7720 VENTURE STREET - STORAGE YARD

Grading & Erosion Control Plans
El Paso County, Colorado

PPR2627

SHEET: C1.1

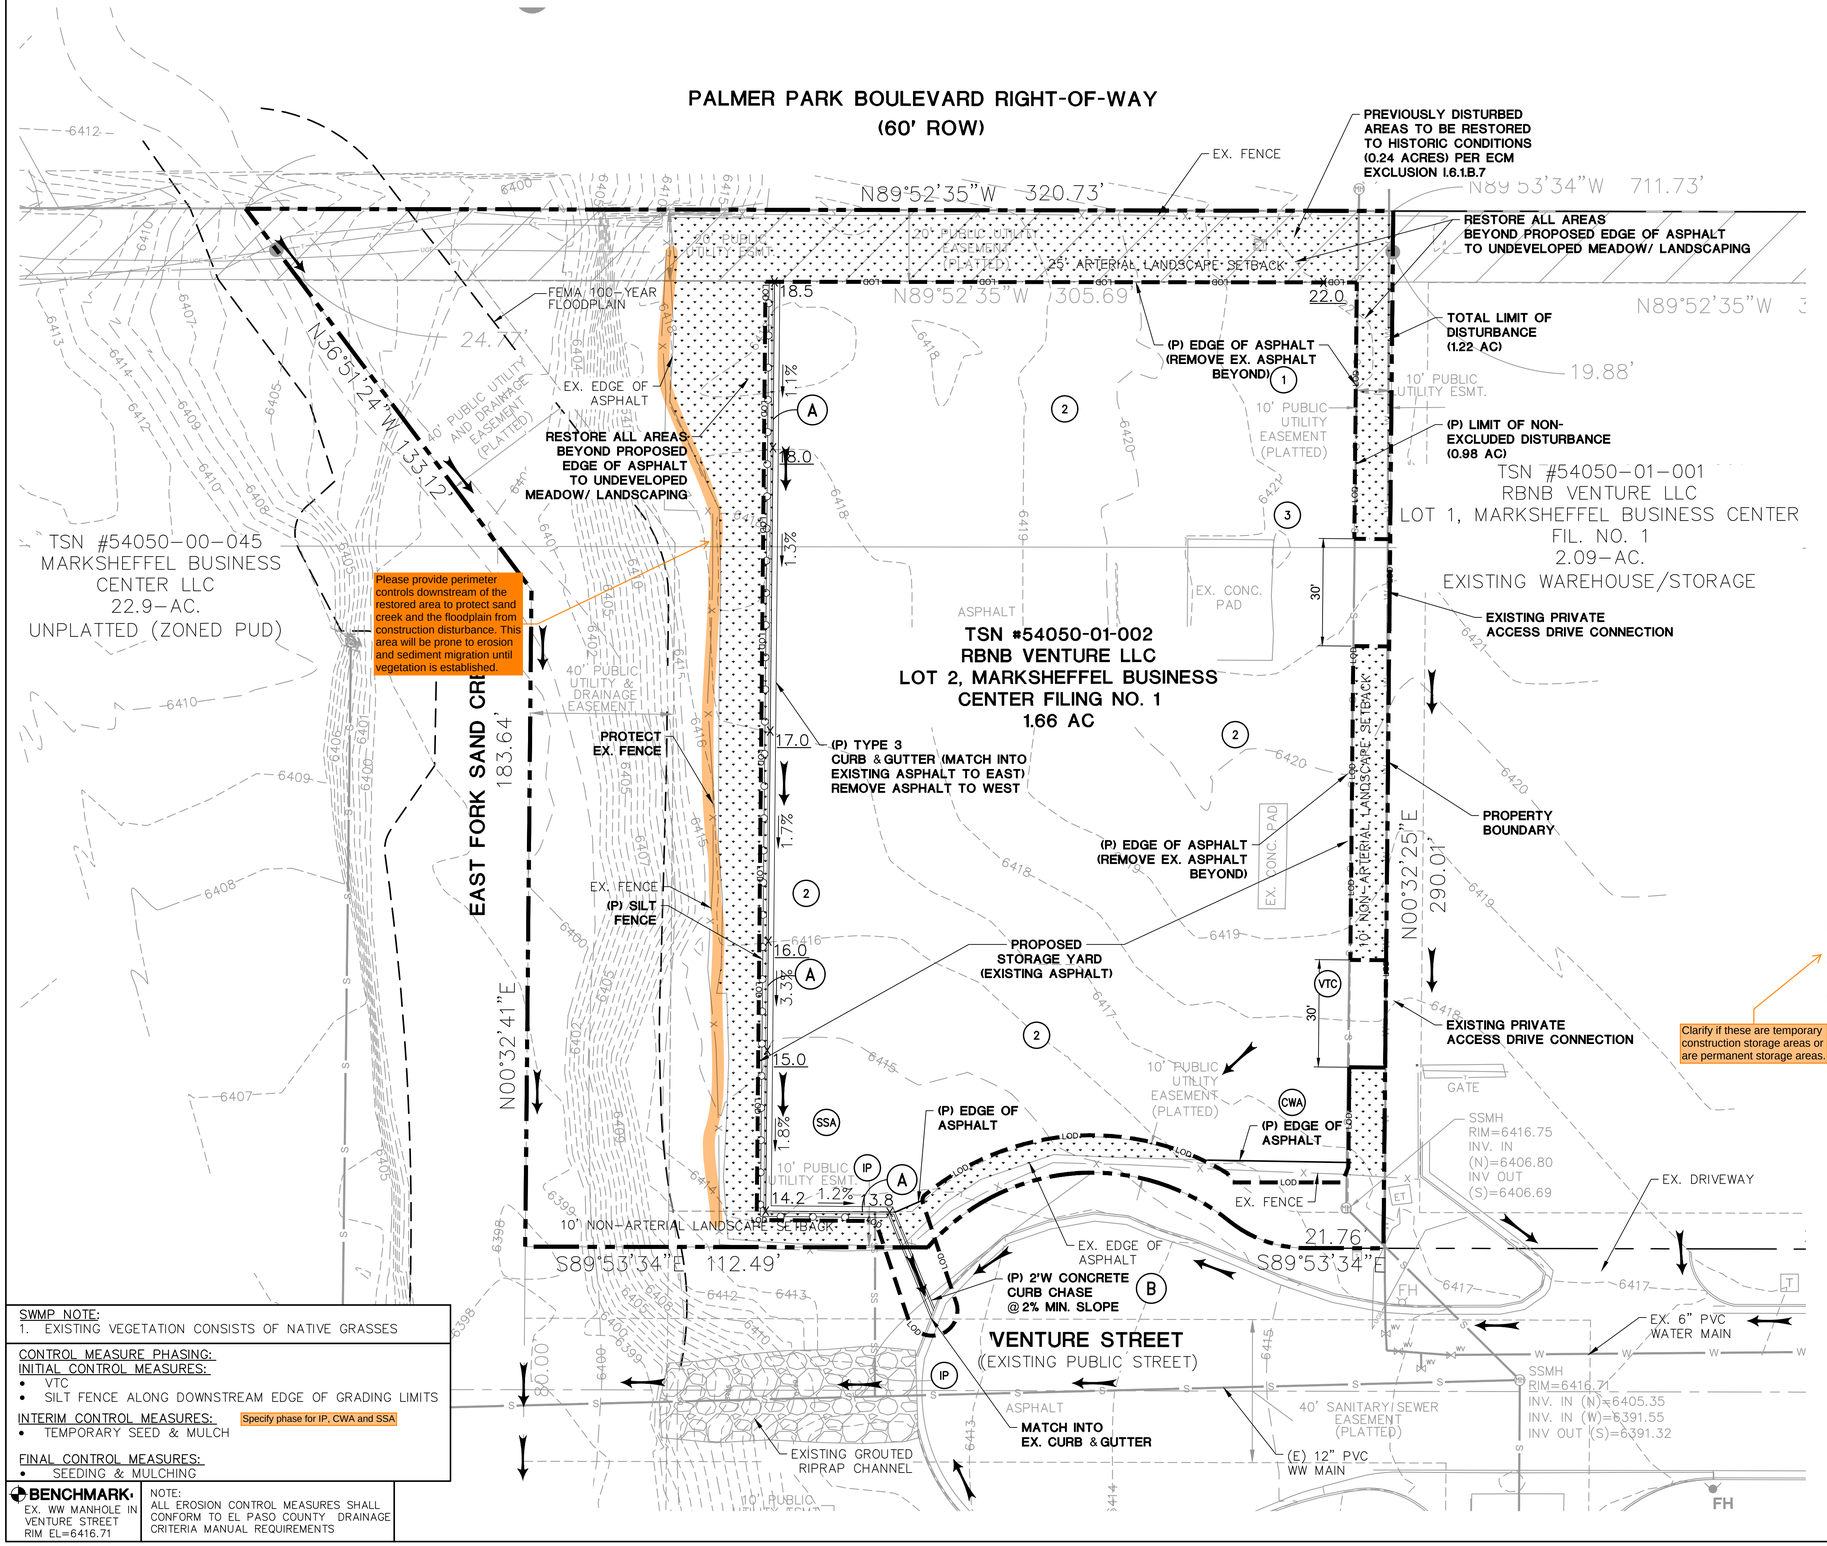
INTERIM CONTROL MEASURES: Specify phase for IP, CWA and SSA
- TEMPORARY SEED & MULCH

SHEET: C3.1

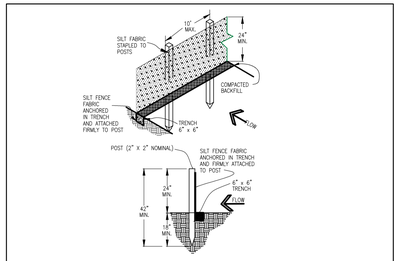
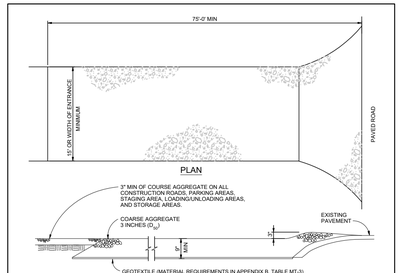
Provide details for the following proposed control measures:
- CWA
- IP
- SM
